## Change Notice Information Announcement

**Product Name(s):** TeSys GV3APN Modification

**Product Line Description:** Manual Motor Protector

**Document Issued:** 7/16/2021

New Product

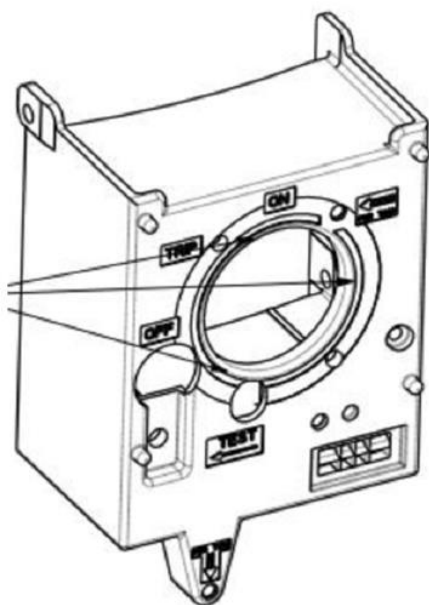
To anticipate new shape of GV3 front cover, the GV2APN handle mechanism shape has been adapted to fit the future flat curve of new GV3 design. New bracket design will be compatible with new and old GV3. No change to ratings or use.
